ADDRESS : 751 RIVER RD SUBDIV:
 CONTRACTOR : STANTON HOMES INC. PHONE : (919) 278-8070
 OWNER : ARNOLD E W C/O WHITSON ARNOLD PHONE :
 PARCEL : 05-0633- - -0001- -02-
 APPL NUMBER: 16-50037835 CP NEW RESIDENTIAL (SFD)
 DIRECTIONS : T/S: 01/12/2016 04:21 PM LBENNETT --
 401 N TURN LEFT ON CHRISTIAN LIGHT RD -
 TURN LEFT ON RIVER RD - PROPERTY IS 1/2
 MILE ON THE LEFT
 T/S: 08/30/2016 10:41 AM DJOHNSON --
 *****PREMISE NO 27024660*****

Reference: Lansberry Residence. Change in Design requested by owner

The owner of the house being built on River Road, Lot 2, F in Fuquay-Varina requested change from the approved plans. The change is to move wall between kitchen and pantry and line wall with Breakfast Area Nook. Plans were reviewed and the changes can be accomplished as follows:

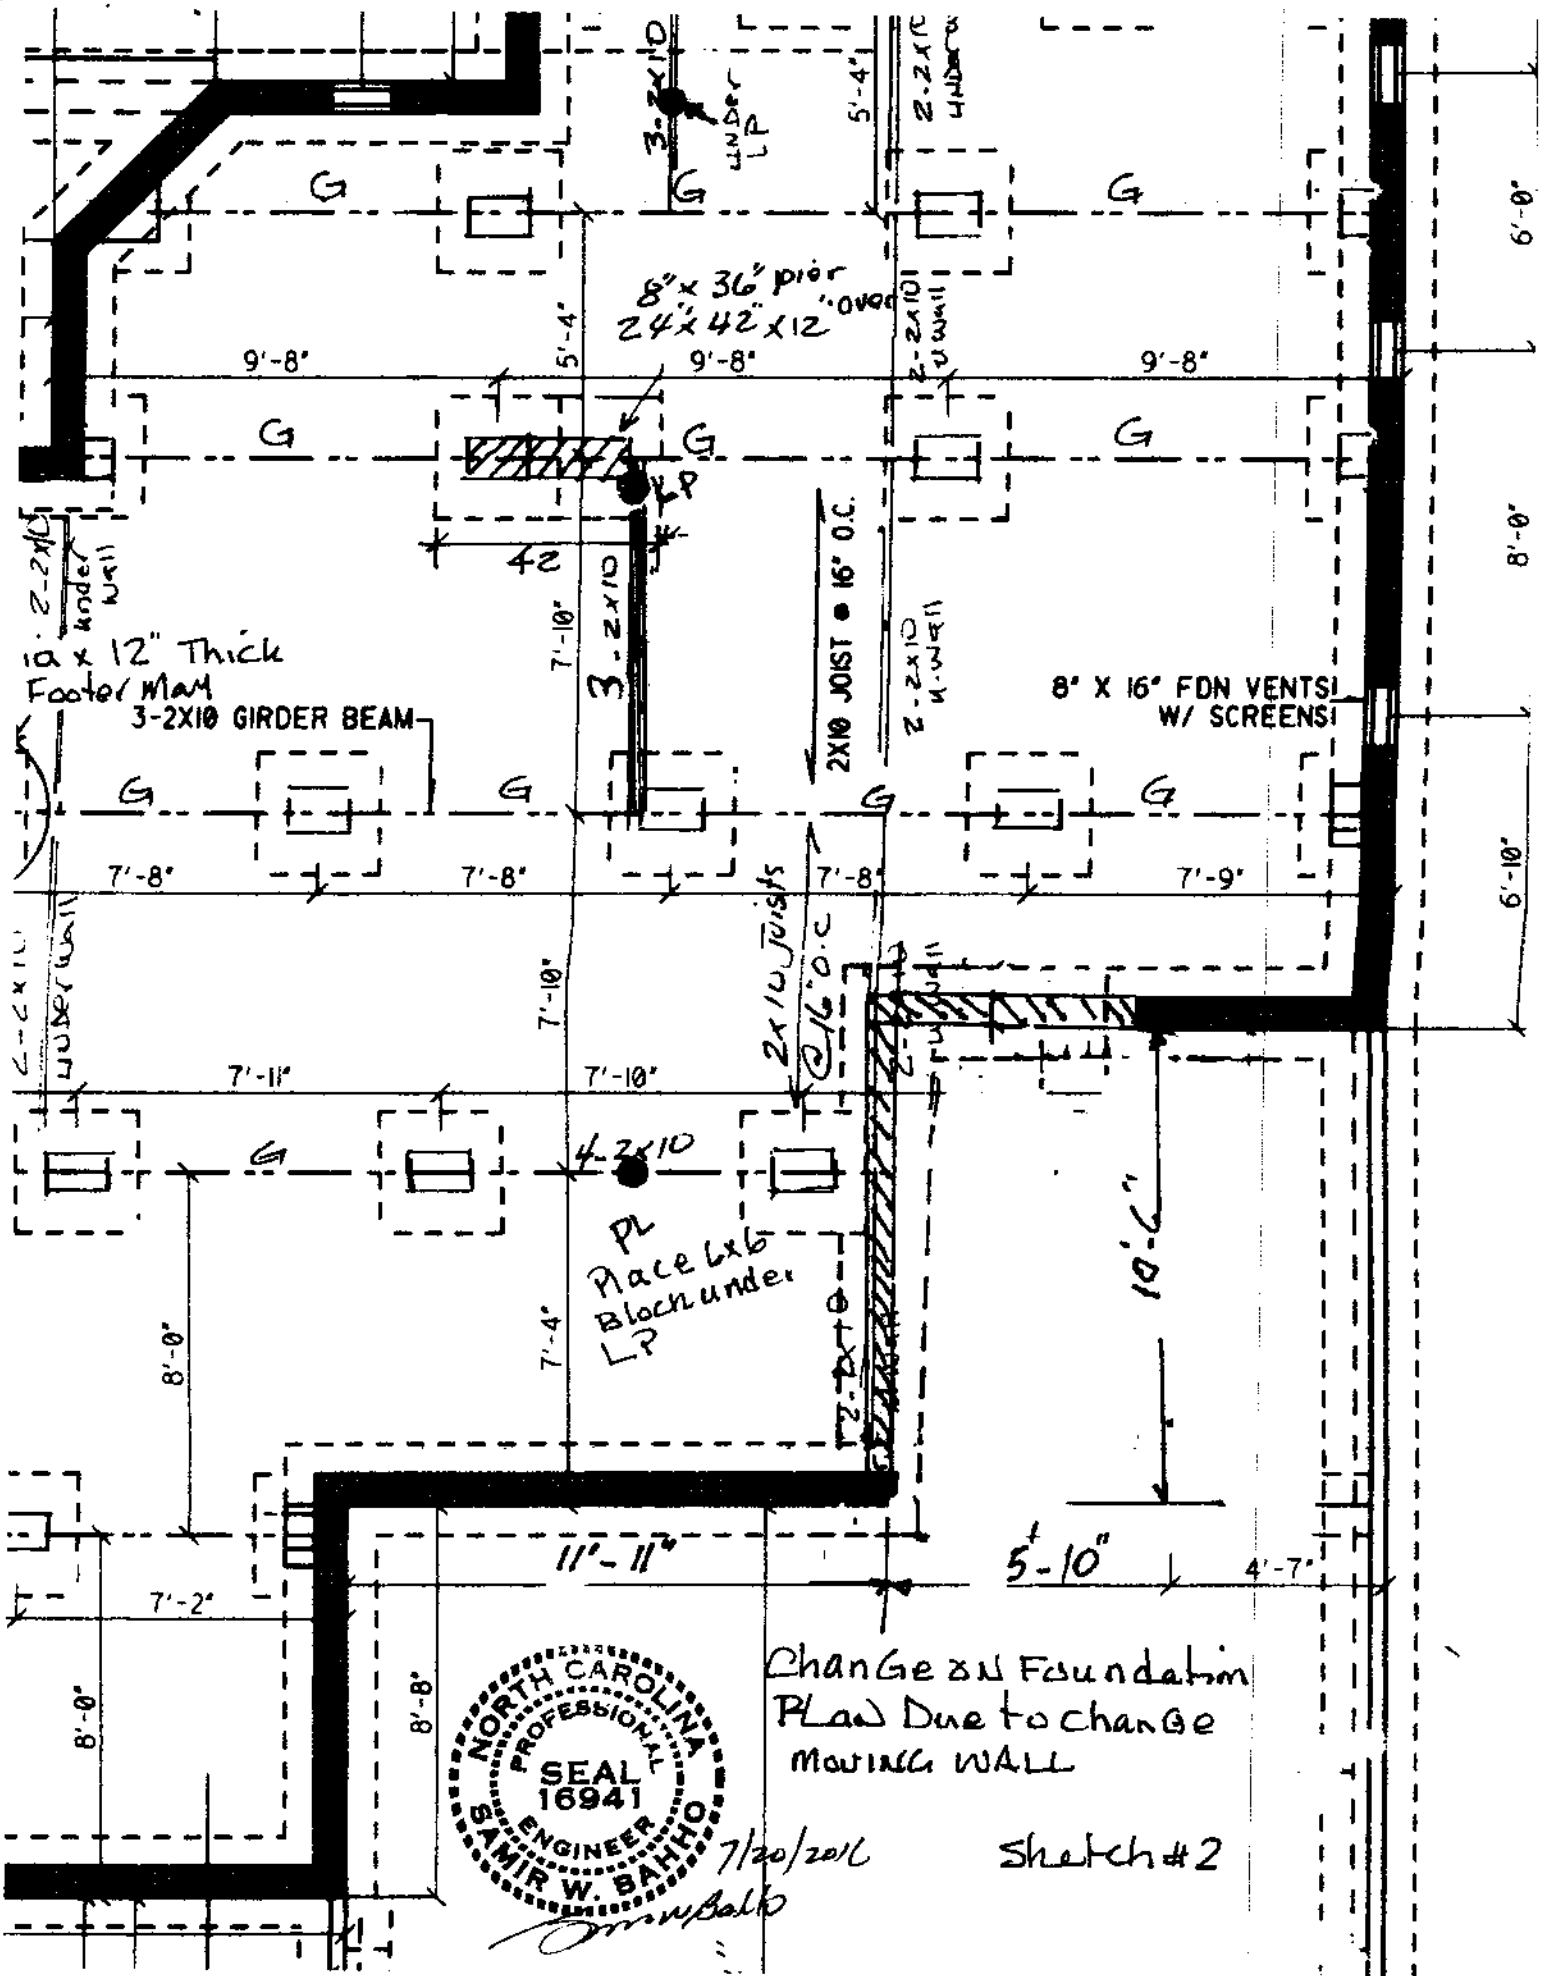
1. Moving of the wall will require the beam to be longer and be 5-1 3/4 x 9 1/4 LVL. Proposed beam shall be bolted together with 5/8" thru bolts spaced at 20" OC and staggered. Beam shall be supported with 6-2x4 on both side and beam shall extend form wall to wall. See attached sketch # 1
2. On foundation plan, the Joist under Load Point on the back side shall be 3-2x10 Joist. Verify that load points as indicated on plans are sitting over joists or provide 6x6 wood blocking between floor and girder at the location of load point. See sketch # 2
3. Sketch # 3 and # 4 are showing originally approved plan at the area of change

Sketch #2

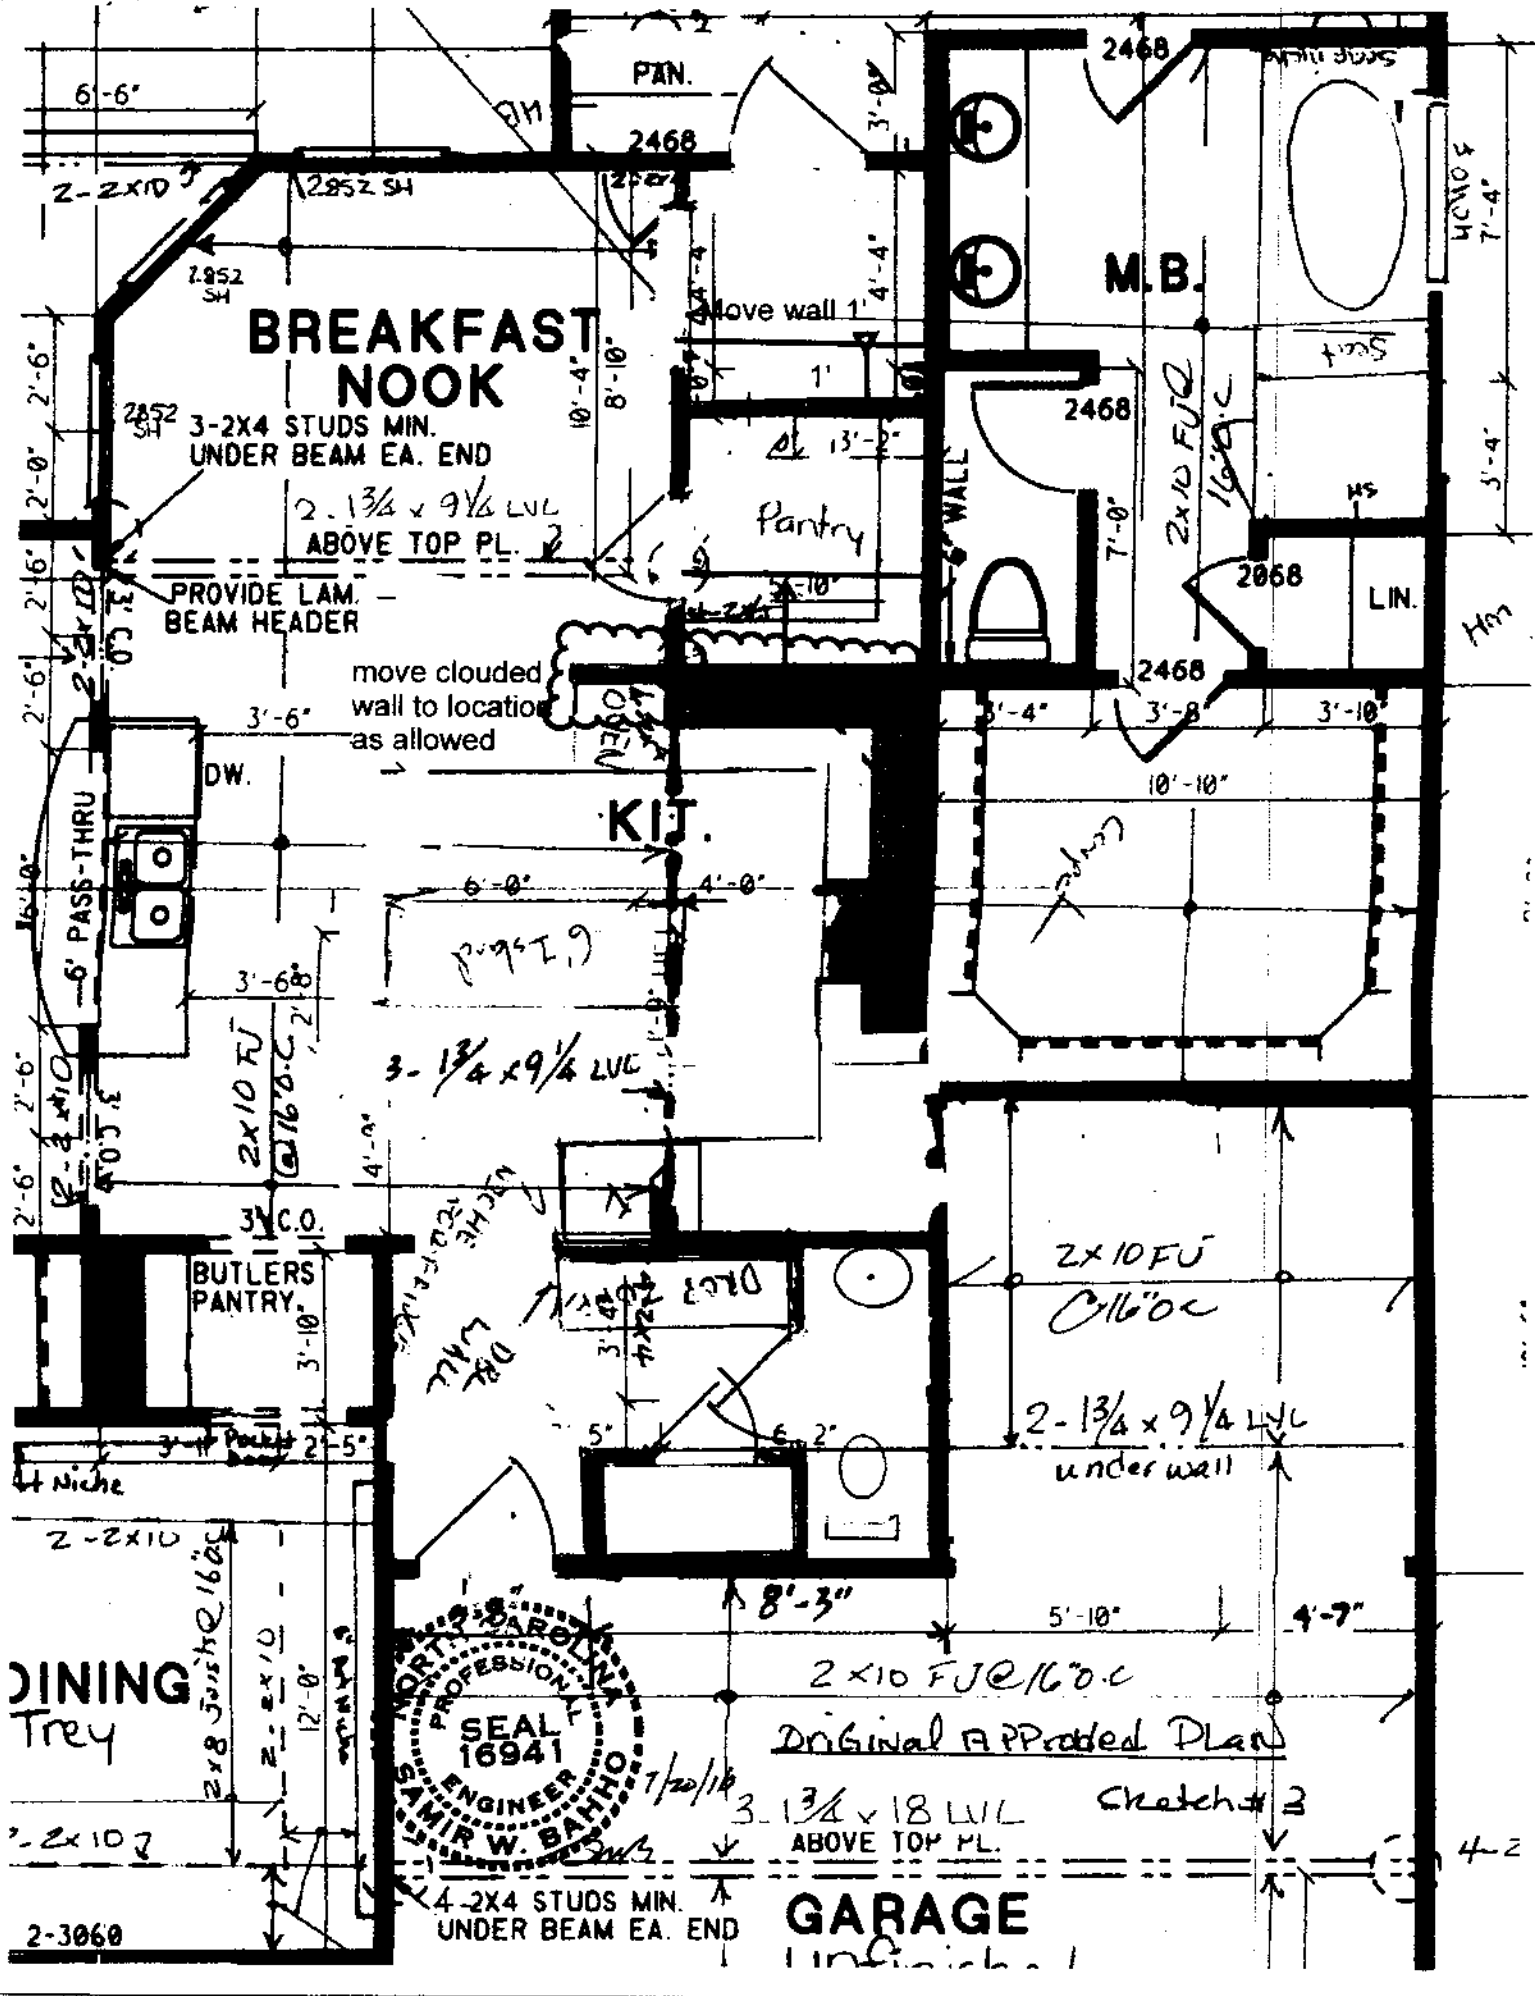
Change all Foundation
Plan Due to change
MOVING WALL
